CONSTRUCTION OF
PAVED
SIDEWALK/DRIVEWAY

Driveway Review Form

Address: 251 Belleville Rd

251 Belleville Rd

Driveway Review

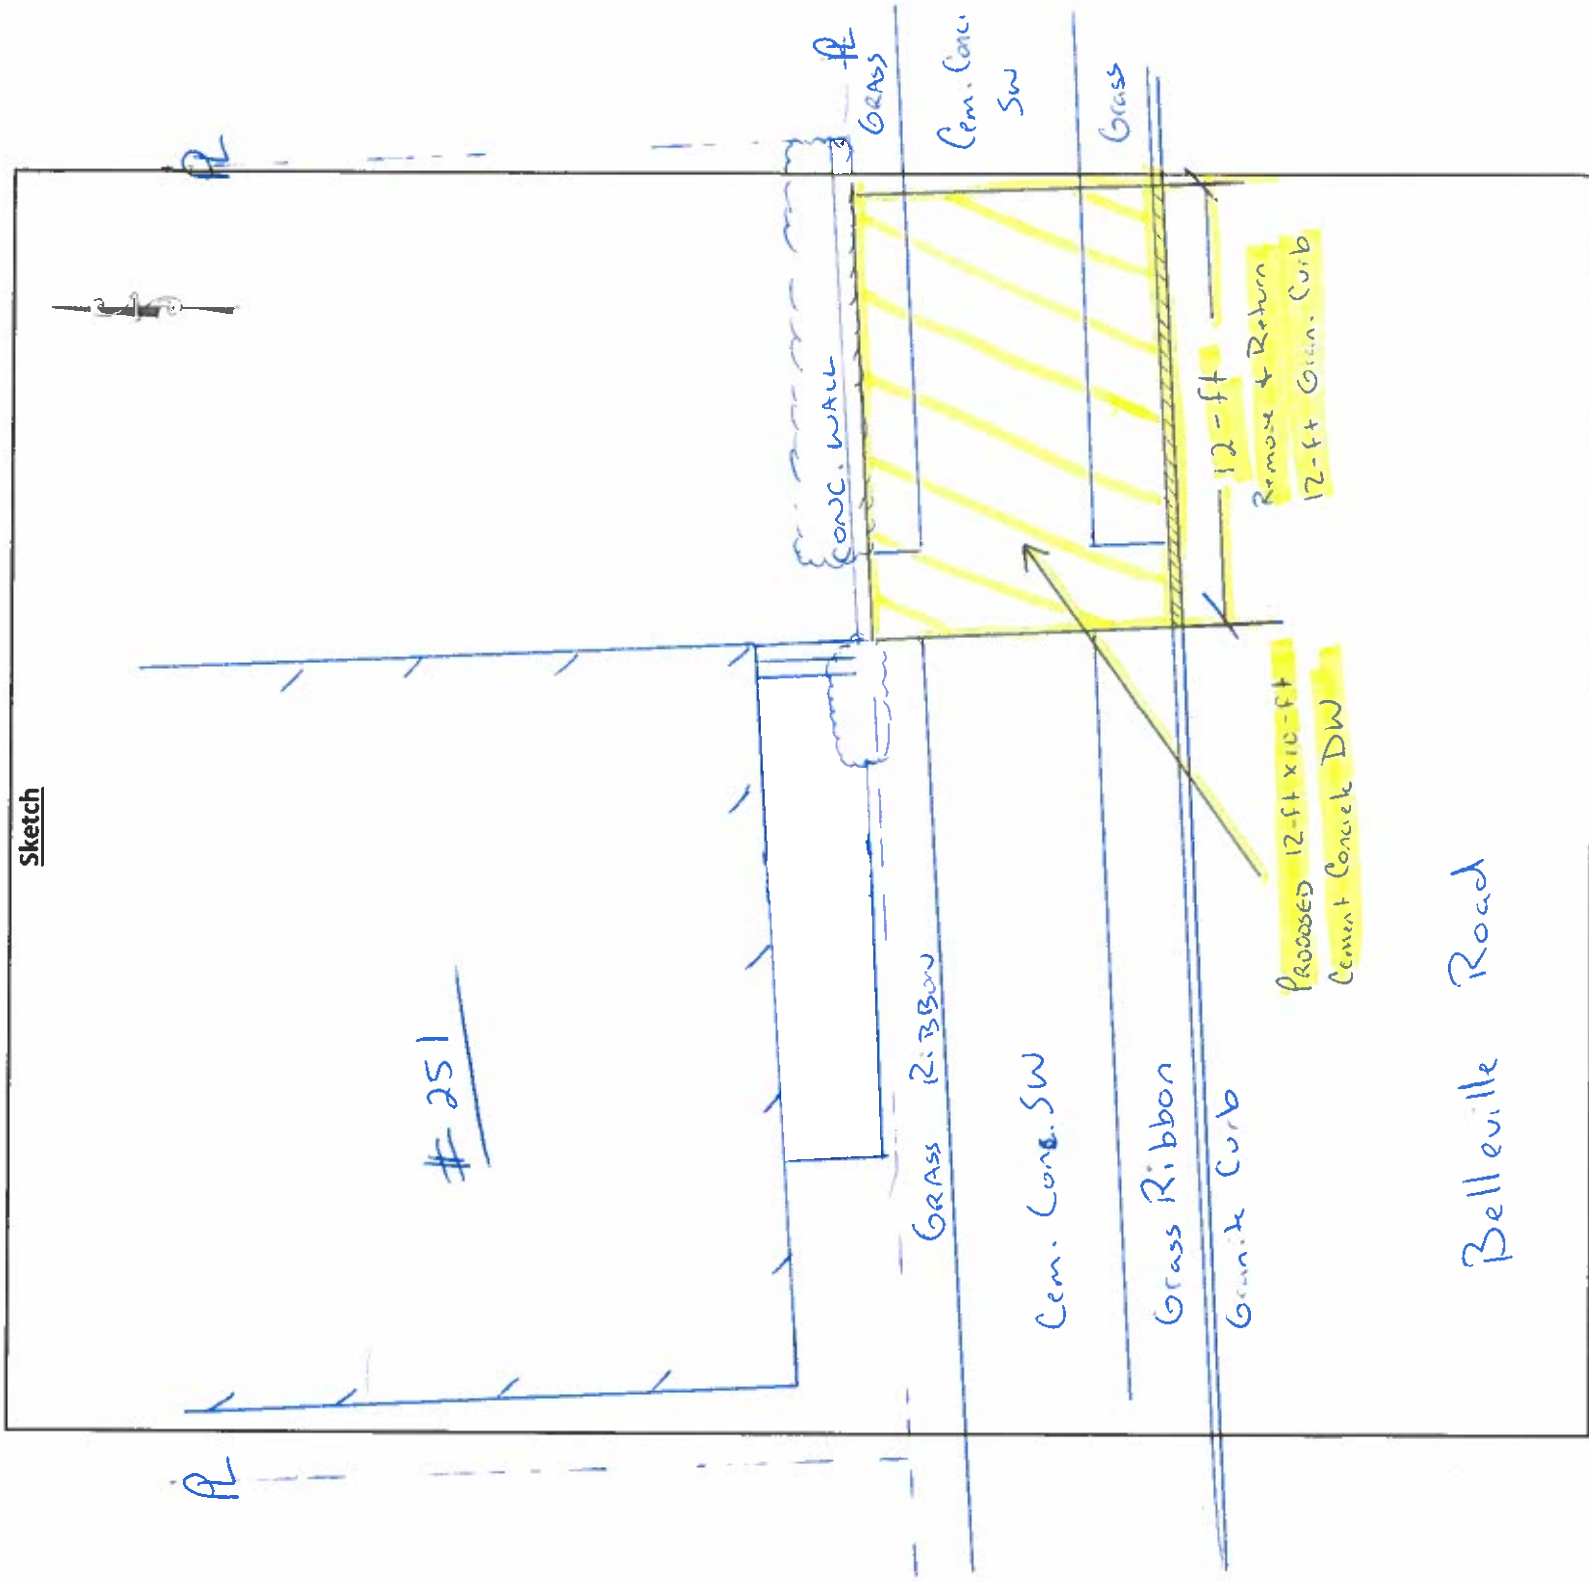
Additional Inspection Notes: 1.Curb return above. 2.Remove 12-ft x 10-ft cem.conc.sidewalk and grass ribbon area. 3.Install new 12-ftx10-ftx6-in cem.conc.driveway apron in accordance with the most current revision of DPI Specs.

Note: Contractor must meet slope requirements for driveway apron, which may require the removal and replacement of abutting sidewalk panels.
